**Merged Document Report****Application No.: PL9379**

PRELIMINARY PLAT
ROYAL OAK SOUTH UNITS 2 & 3
CORPUS CHRISTI, NUECES CO., TX

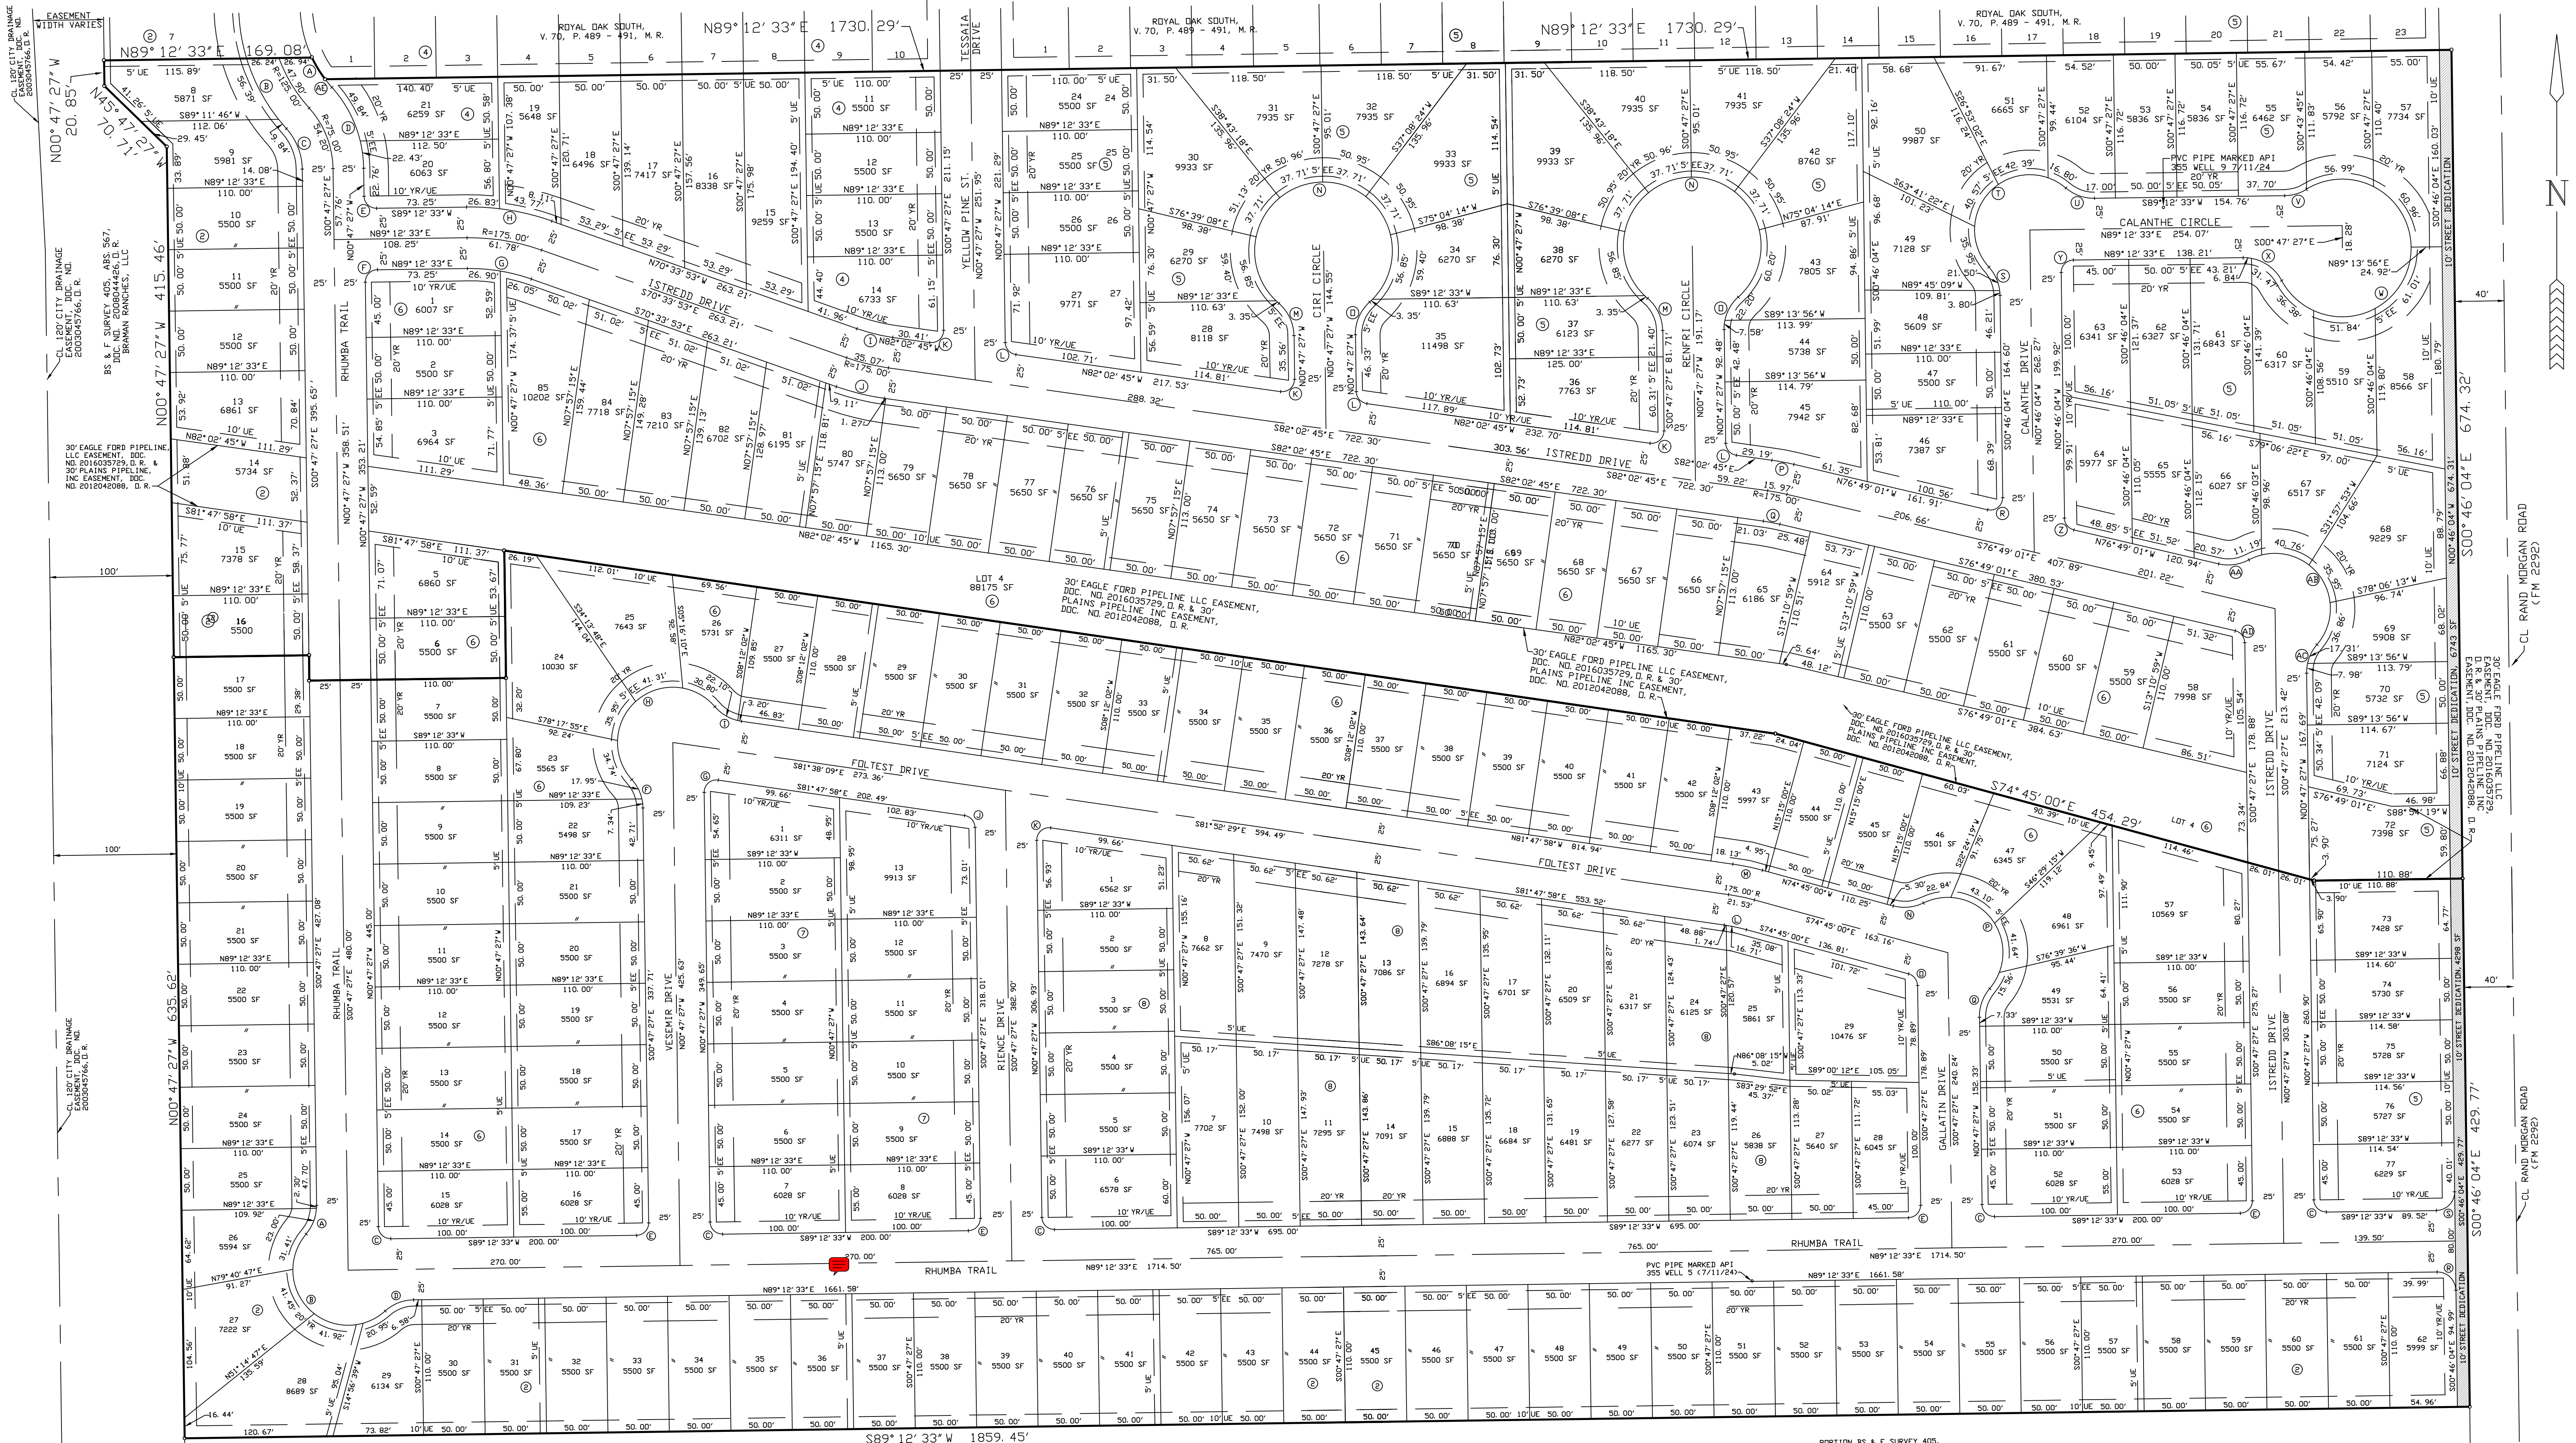
Comment ID	Page Reference	Annotation Type	Author : Department	Status	Review Comments	Applicant Response Comments
1	P001	Note	Bria Whitmire : DS	Closed	Improvements Required for Recordation, per UDC 8.1.4. A. Streets: yes Sidewalks: yes B. Water: yes (EACH lot must have individual access and provide connectivity to neighboring lot) Fire hydrants: yes (nearest hydrant must be 300 feet for commercial, 600 for residential) C. Wastewater: yes (EACH lot must have individual access and provide connectivity to neighboring

Comment ID	Page Reference	Annotation Type	Author : Department	Status	Review Comments	Applicant Response Comments
					lot) D. Stormwater: yes, site development must mitigate any increase of stormwater runoff-post development flow cannot exceed pre development flow E. Public open space: no (UDC 8.3) F. Permanent monument markers: no Please note, improvements required should be constructed to city standards, found in Article 8 and the IDM.	
2	P001	Note	Mark Zans : LD	Closed	Provide street cross sections for all street types and include the sidewalks. for this preliminary plat.	
3	P001	Note	Mark Zans : LD	Closed	Traffic comments: PLAT – ROADWAY MASTER PLAN •The proposed plat does not impact or alter the existing Transportation Master Plan. - oPlat as submitted is not approved. The property line shall be moved inward to clearly designated the ROW width. PLAT – COMMENT: (CITY ACCESS MANAGEMENT / ROW) •A ROW Construction Permit, issued by PW-Traffic Department (Right-of-Way Division), is required for any proposed driveway (construction entrance, temporary or permanent), work obstructing, closing, or occupying public right-of-way (Reference Chapter 49-2). - oThe ROW Construction permit must be submitted and approved prior to any form of construction within City ROW. - oThe developer / applicant can reach out to rowmanagement@corpuschristitx.gov for further assistance regarding the ROW Construction Permit they will be required to submit prior to any temporary and / or permanent driveway off the immediate roadways. - oAny contractor working within City ROW without an approved ROW Construction Permit can be held in non-compliance and can be subject to a fee of \$1,500 per day of unpermitted work, as per City of Corpus Christi Municipal Code 49-112 (9). •The PW-Traffic Department (Right-of-Way Division) is responsible for reviewing and permitting new construction and repairs/modifications to driveways, sidewalks, curb, and gutter or any work within utility easements. - oAll work shall be performed in accordance with the city's construction standards. A permit shall not be issued for any tract or property where a final plat is required to obtain a building permit. (Refer to Muni-code Chapter 49-30 for permit requirements.)

Comment ID	Page Reference	Annotation Type	Author : Department	Status	Review Comments	Applicant Response Comments
4	P001	Note	Mark Zans : LD	Closed	Per UDC 8.2.4 block length cannot exceed 1600feet. Rhumba Trail block length is 1661.58"	
7	P001	Note	Mark Zans : LD	Closed	Fire comments#1 Water Distribution Standards: Fire flow for residential areas requires 750 GPM with 20 psi residual 507.5.1 Exception 1: Group R-3 (one- or two-family dwellings): Fire hydrants to be located every 600 feet apart. 3310.1 Required access. Approved vehicle access for firefighting shall be provided to all construction or demolition sites. Vehicle access shall be provided to within 100 feet of temporary or permanent fire department connections. Vehicle access shall be provided by either temporary or permanent roads, capable of supporting vehicle loading under all weather conditions. Vehicle access shall be maintained until permanent fire apparatus access roads are available. D102.1 Access and loading. Facilities, buildings, or portions of buildings hereafter constructed shall be accessible to fire department apparatus by way of an approved fire apparatus access road with an asphalt, concrete or other approved driving surface capable of supporting the imposed load of fire apparatus weighing at least 75,000 pounds. 503.2.1 Dimensions. Fire apparatus access roads shall have an unobstructed width of not less than 20 feet, exclusive of shoulders and an unobstructed vertical clearance of not less than 13 feet 6 inches.

8	P001	Note	Mark Zans : LD	Closed	Fire comments #2 Information/Note: 1. Where Fire Apparatus Access is constructed to the minimum of 20 feet, no parking is allowed within the fire apparatus lane. 2. Where a fire hydrant is located on the street, the minimum unobstructed clearance shall be 26 feet. In this instance, no parking is allowed on one side of the street. 3. The minimum street width is 28 ft. curb to curb. Any parking along the street that reduces the width to less than 20 ft. is prohibited and the Fire Code Official and will require painting "NO PARKING-FIRE LANE" along one side of the street. Note: Calculated Turning Radii for Fire Apparatus: Inside Turn: 28 ft. Curb to curb: 36 ft. 8 in. Wall to wall: 44 ft. 8 in. Note: The turning radius for fire apparatus should

Comment ID	Page Reference	Annotation Type	Author : Department	Status	Review Comments	Applicant Response Comments
					not be less than 45 degrees and curb to curb 36 feet. As a result, developers should be particularly careful not to design streets with acute angles that would prevent fire apparatus from completing a turn without having to back up to negotiate the turn. 503.4 Obstruction of fire apparatus access roads. Fire apparatus access roads shall not be obstructed in any manner, including the parking of vehicles. The minimum widths and clearances established in sections D103 shall always be maintained. 503.3 Marking: Where required by the fire code official, approved signs, or other approved notices the include the words NO PARKING-FIRE LANE shall be provided for fire apparatus access roads to identify such roads to prohibit the obstruction thereof. The designation of a fire lane can be marked with conspicuous signs which have the words:" Fire Lane-No Parking" at 50-foot intervals. In lieu of signs, fire lanes may be marked along curbing with the wording, "Fire Lane-No Parking" at 15-foot intervals. D107.1 One- or two-family dwelling residential developments. Developments of one- or two-family dwellings where the number of dwelling units exceeds 50 shall be provided with two separate and approved fire apparatus access roads. Exceptions: 1. Where there are more than 50 dwelling units on a single public or private fire apparatus access road and all dwelling units are equipped throughout with an approved automatic sprinkler system, access from two directions shall not be required. 2. The number of dwelling units on a single fire apparatus access road shall not be increased unless fire apparatus access roads will connect with future development, as determined by the fire code official.

9	P001	Note	Bria Whitmire : LD	Closed	Stormwater comments: While the applicant has acknowledged our comments, they have deferred nearly all detailed engineering requirements to the Public Infrastructure (PI) phase by stating "PI's conform to UDC and IDM requirements". Therefore, these comments are not yet resolved and must be formally carried forward. Please include the following conditions, noting that all comments must be fully addressed and approved during the PI phase prior to final plat recordation:

5	P001	Note	Caleb Wong : STREET	Closed	PW STR: IDM Table 6.2.2.B Non-Local Street Standards or Table 6.2.2.C Rural Street Standards, please provide typical cross section of proposed streets and/or Mobility Plan facilities consistent with latest Infrastructure Design Manual (On Preliminary Plat and Final if not provided on a previous Preliminary plat).	
6	P001	Note	Caleb Wong : STREET	Closed	PW STR: The developer shall be required to utilize the most stringent of sections per classification of roadway without a Geotech report validating the soil type. Please provide geotech validating typical sections and refer to IDM when constructing pavement section.	
12	P001	Note	Caleb Wong : STREET	Closed	PW STR: PW Streets will accept the preliminary plat. However, approval of the plat does not approve the layout of the roadways and the typical sections. These will be reviewed in depth in the Public Improvement Plans. For the typical sections, please provide the geotechnical report used for our review.
